Statement of Response to LRD Opinion

**Prepared in Respect of a Planning
Application for a Large-Scale Residential
Development at a Site in the Townlands
of Glenamuck North, Kilternan, Dublin 18
(Southern Site)**

**On Behalf of Durkan Glenamuck
Developments Limited**

December 2025

Figure 2.3: Existing Site Layout Plan (Outlined in Red) with the Vehicular Access Restrictions Identified

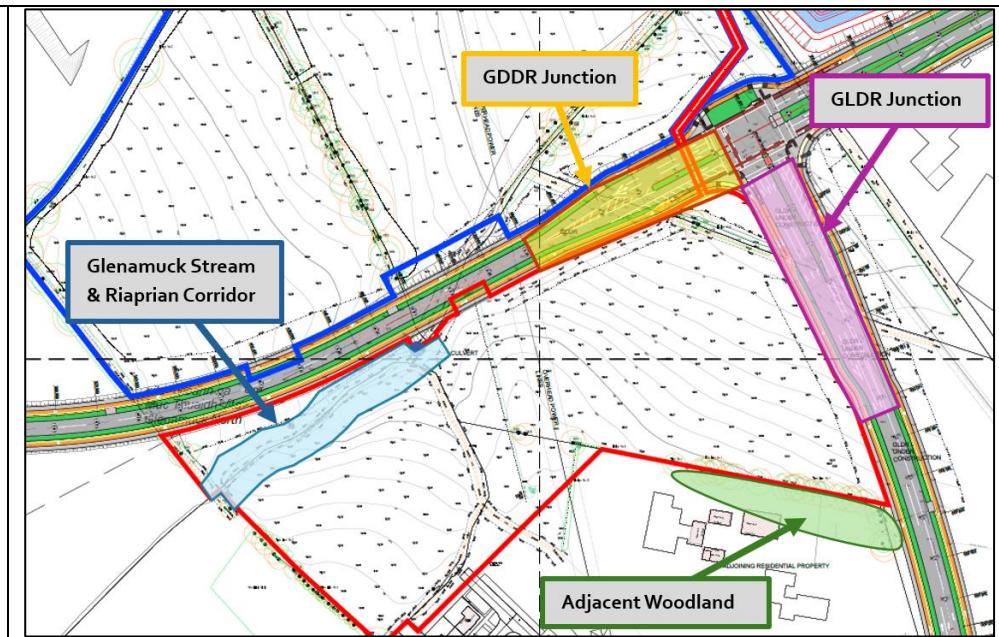
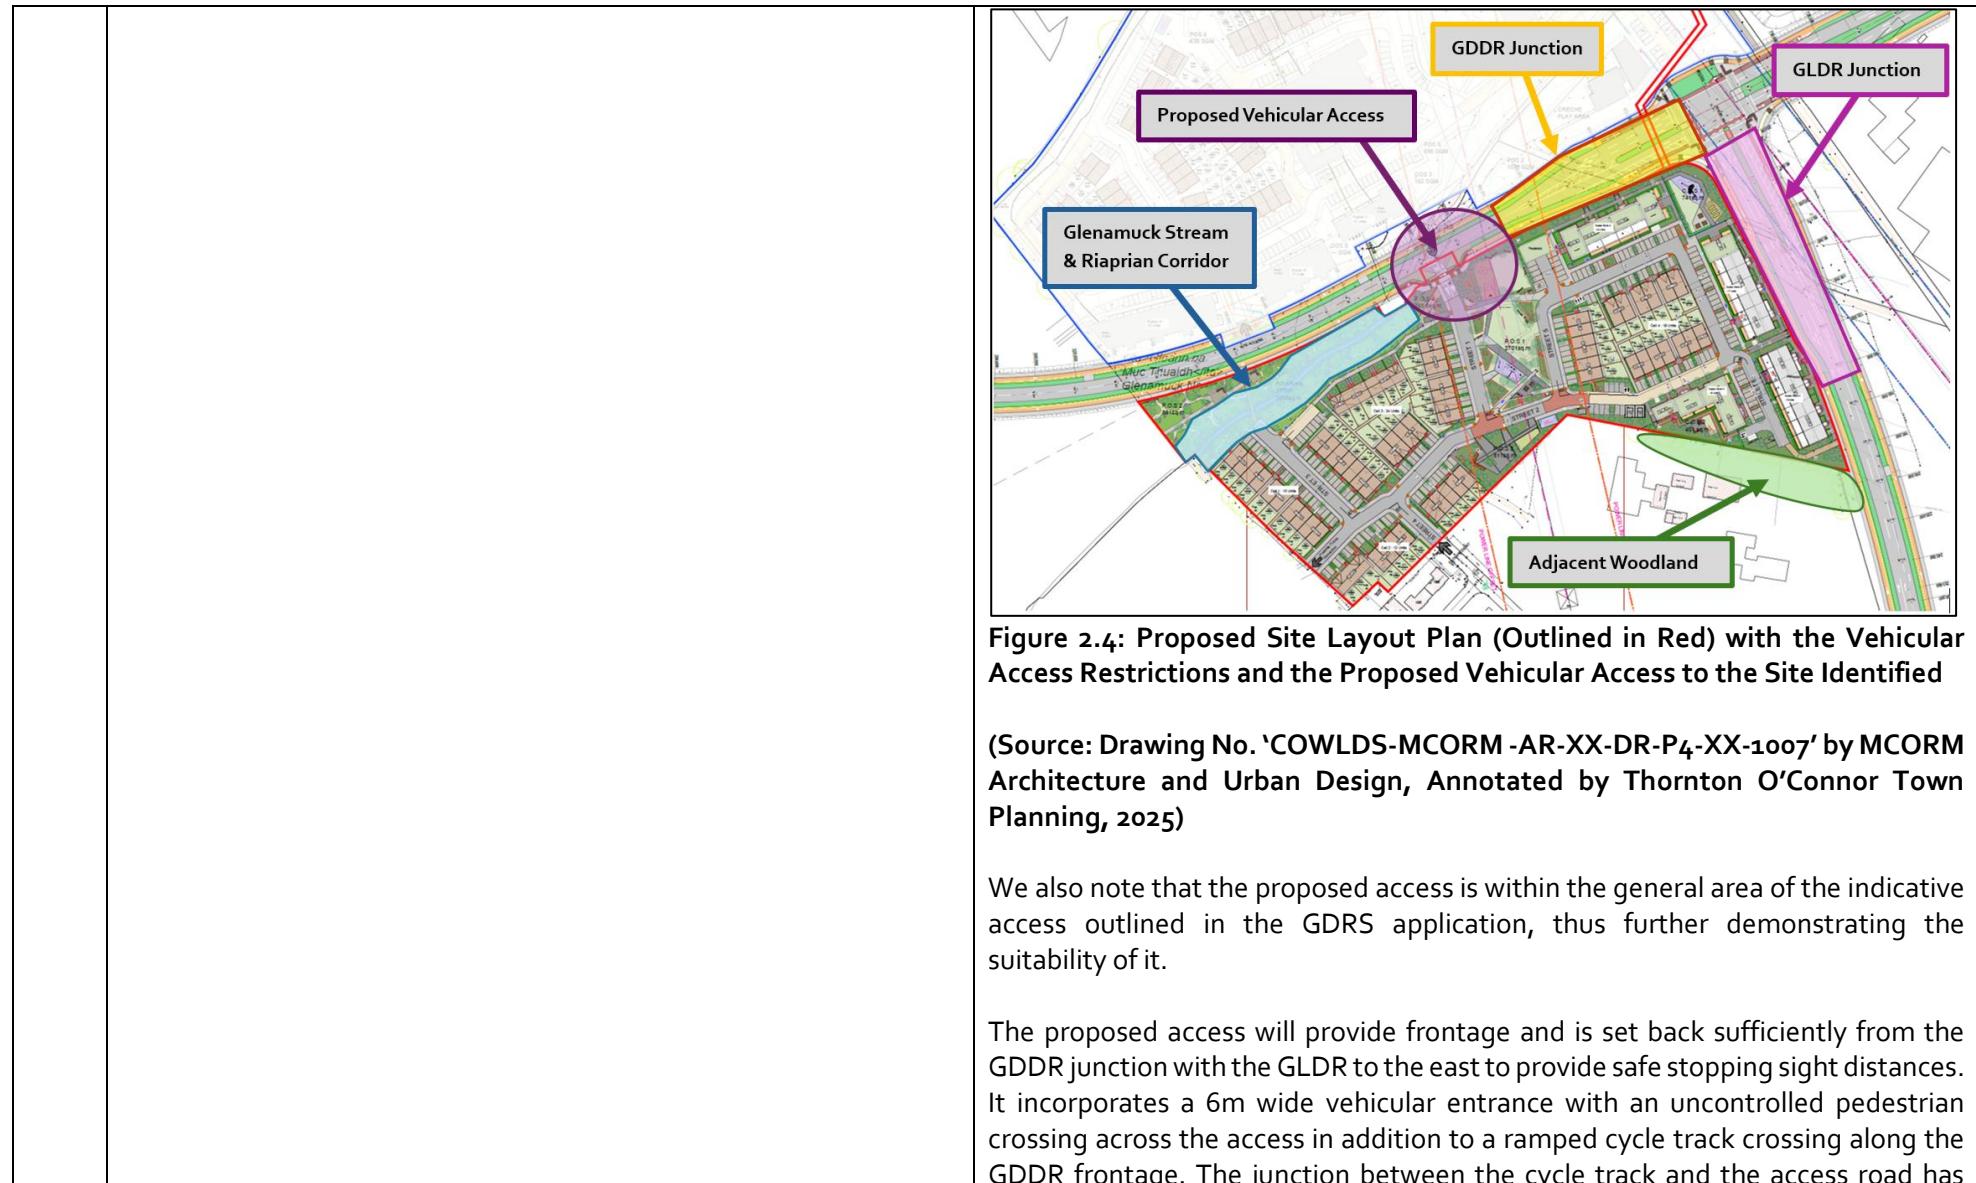
3.	<p>Vehicular Access onto GDRS Scheme: The Applicant will be required to submit a detailed justification for the location and design of the proposed vehicular access onto the GDRS. The proposed layout shall also be subject to a detailed Road Safety Audit.</p> <p>All potential impacts to the GDRS scheme and existing local road network shall be assessed in detail by way of a Traffic Impact Assessment which shall include for relevant committed developments.</p>	<p>The location of the proposed vehicular access point to the site from the GDRS has been thoroughly considered by the Applicant and Design Team having regard to the following:</p> <p>1. <i>Junction Envisaged in the GDRS Application</i></p> <p>An indicative location of an access to the subject site was identified as part of the Glenamuck Distributor Roads Scheme (GDRS) application (ACP Reg. Ref. HAo6D.303945), as illustrated in Figure 2.2 below.</p>  <p>Figure 2.2: Future Junction Access at the Subject Site Envisioned in the GDRS</p> <p>(Source: As submitted under ACP Ref. HAo6D.303945, Annotated by Thornton O'Connor Town Planning, 2025)</p>

<p>The retention and enhancement of the stream has been a fundamental consideration in the design of the proposed scheme. In this regard, it was not considered appropriate to locate a vehicular access along the western extent of the site's northern boundary as this would necessitate either the construction of a bridge over the stream or the culverting of the watercourse. Such works would conflict with the design objectives of the scheme and result in unnecessary intervention within and adjacent to the stream corridor. Accordingly, a vehicular access cannot be provided at this location.</p> <p><i>4. Possible Visibility Splay Issues Along GLDR from Adjacent Woodland</i></p> <p>There is space along the eastern boundary of the site, further south of the GLDR junction, which has potential to facilitate a new vehicular access to the site. However, there is a blanket of trees located outside the subject site's southern boundary (and outside the control of the applicant) which abuts the eastern extent of the boundary and continues eastwards toward the GLDR. If a vehicular access was to be provided at the south-eastern corner of the site, then some of these trees may require removal or the canopies of the trees would require regular upkeep and maintenance to ensure sufficient visibility splays are provided from the access at all times.</p> <p>Not only are these trees outside the ownership of the applicant and therefore beyond the remit of this planning application, but all reasonable efforts have been made to ensure that the proposed development does not adversely affect these trees given their landscape and ecological value. In our opinion, a vehicular access cannot be provided at this location.</p> <p><i>5. Proposed Vehicular Access</i></p> <p>The restrictions posed by the GDDR and GLDR junction layouts relative to the site's boundary, the location of the Glenamuck Stream and its Riparian Corridor across the site, and the area covered by the existing blanket of trees are outlined on the existing site layout plan provided in Figure 2.3.</p>

Figure 2.4 provides these same features but on the proposed site layout which clearly illustrates that the proposed new vehicular access along the site's northern boundary is the most appropriate location to provide such access.

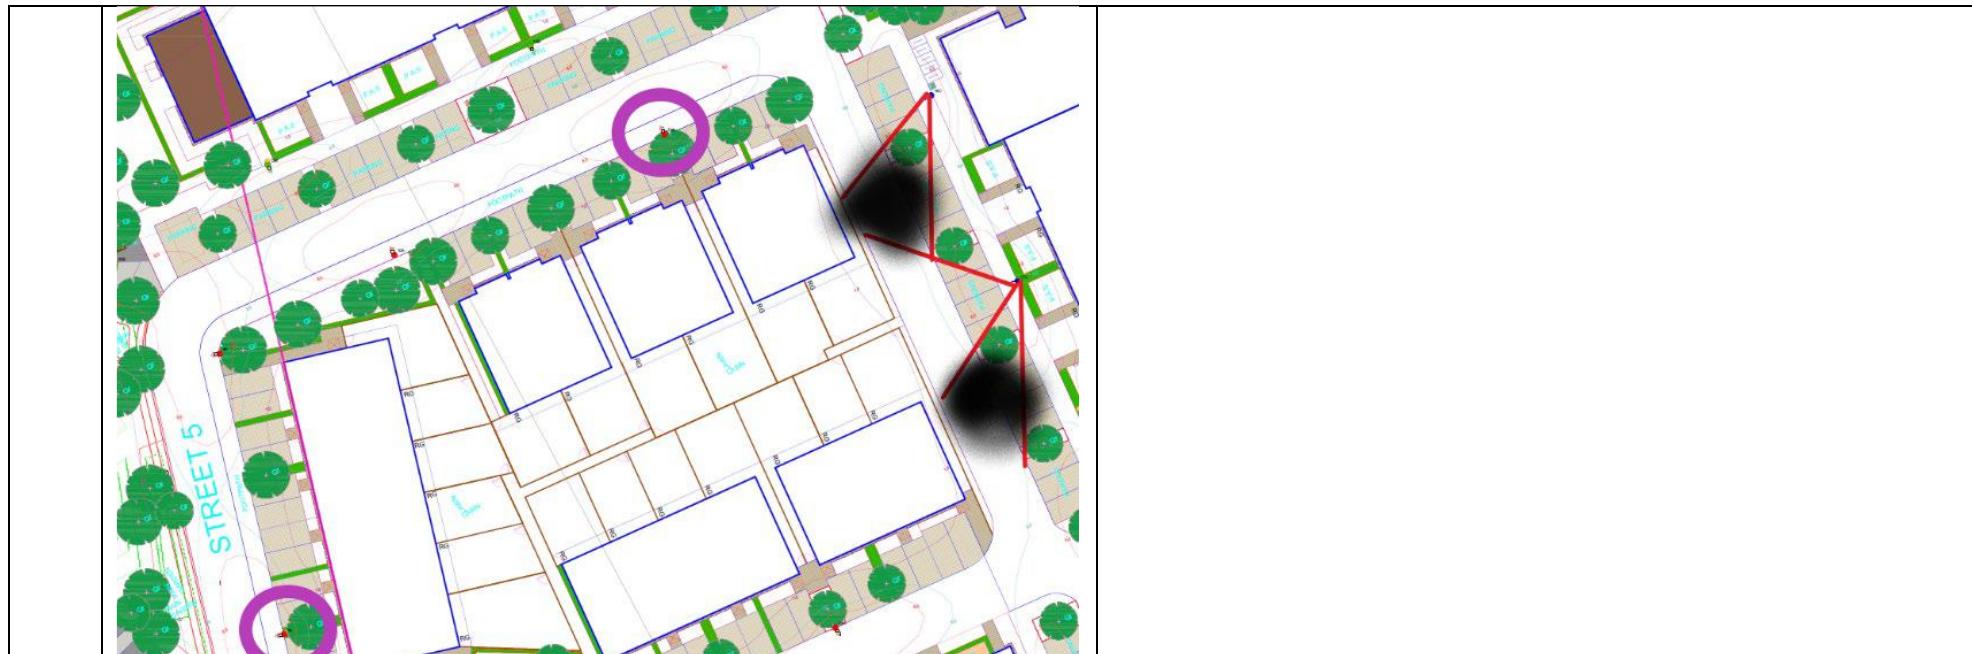
3.	<p>It should be noted that Microdrainage has default Cv values of 0.84 for Winter and 0.75 for Summer. These should be amended to a value of 1.0, particularly where applicants are proposing reduced PIMP(%) values. Maintaining the default Cv values reduces the run-off in simulations of rainfall events, giving inaccurate simulation results which may lead to undersizing of the drainage system and attenuation storage.</p> <p>The applicant is requested to resubmit their Microdrainage calculations using the correct total contributing area, and either PIMP(%) of 100 or Cv values of 1.0, and site specific or local data, such as SAAR, Soil Type, Rainfall Return Period Table (available from MET Eireann), rainfall intensity and other hydrological parameters. The applicant must clearly state and justify all inputs used in Microdrainage and agree these with Drainage Planning prior to submission of the final application.</p>	<p>The Cv values have been set to 1.0 for both summer and winter events in the calculations provided. The Met Éireann data has also been provided which include the SAAR=994, M5/60=16.0mm and r=0.276.</p>
